Avon Advisory Planning Commission Meeting
Monday, February 23, 2026 at 6:30 pm
at Avon Town Hall

4.1. DPR 25-12: Park Place Crossing

Planning & Building Department Staff Report

Exhibit C – Planning TAC Letter (Page 1 of 4)

Exhibit E – Aerial Photo w/ Measurements of Proposed Driveway Separation

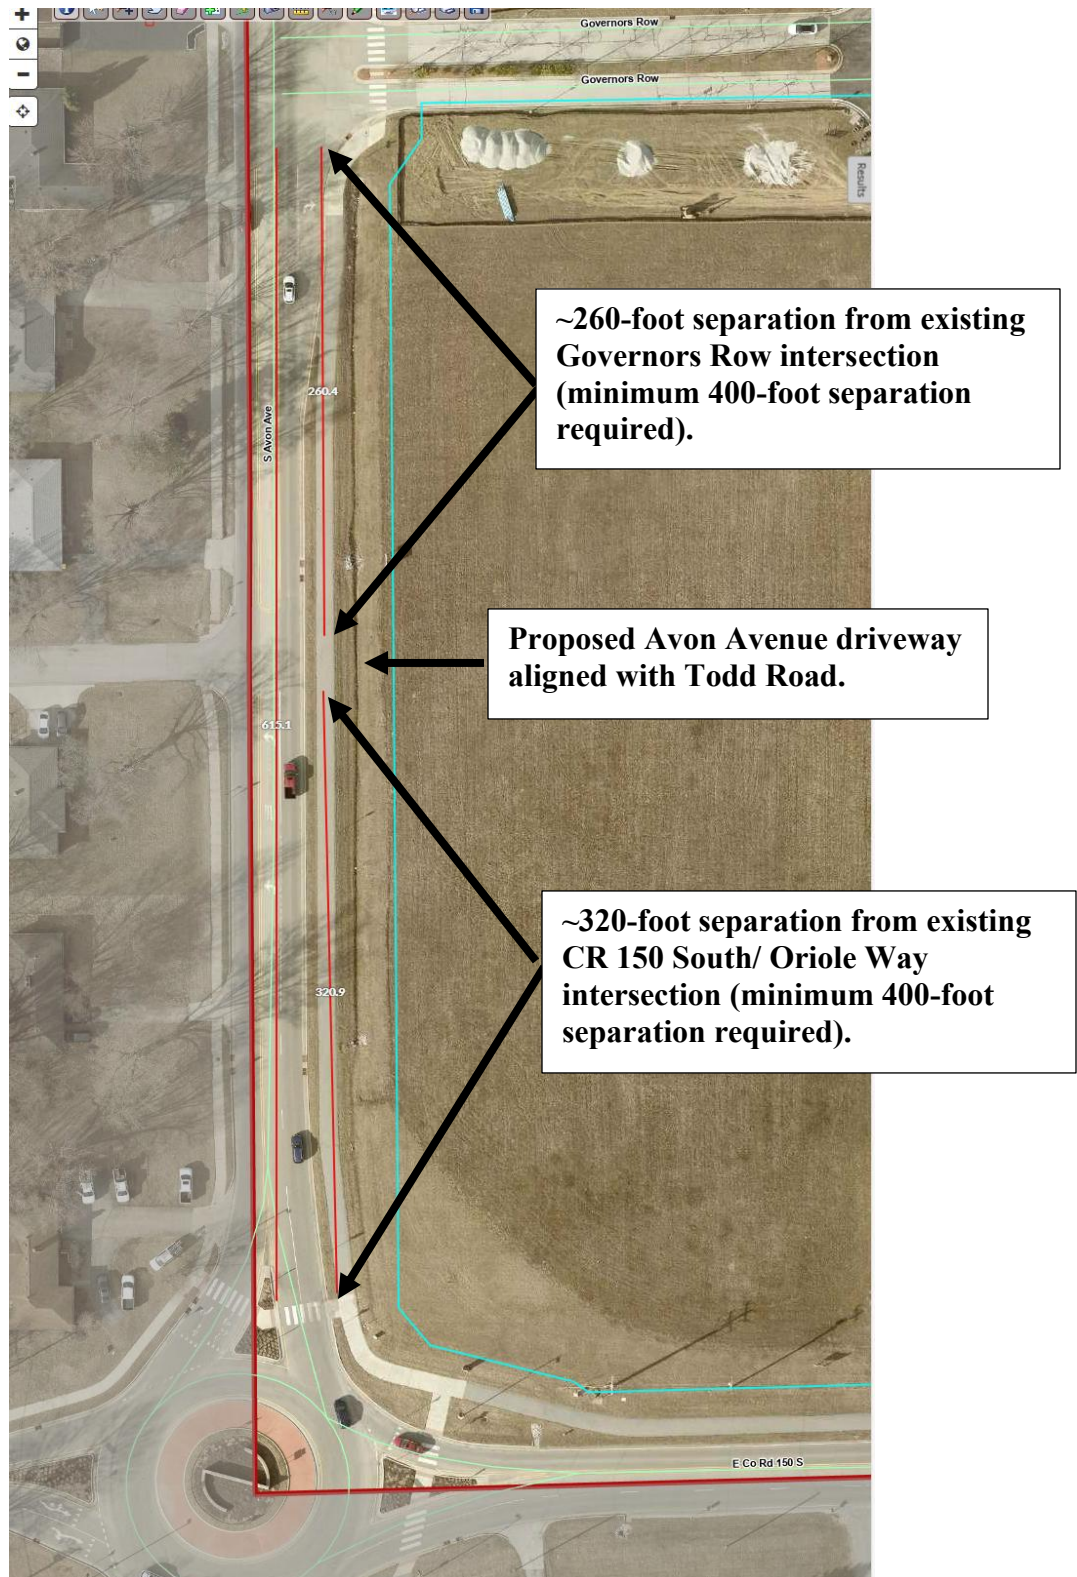
UDO 8.10(F)(4) requires that development plans provide traffic circulation that creates conditions favorable to the health, safety, and harmonious development including street and highway access points that minimize safety hazards and congestion by their design and location, and that capacity of adjacent streets and highways is sufficient to safely and efficiently accept traffic generated by the proposed development.
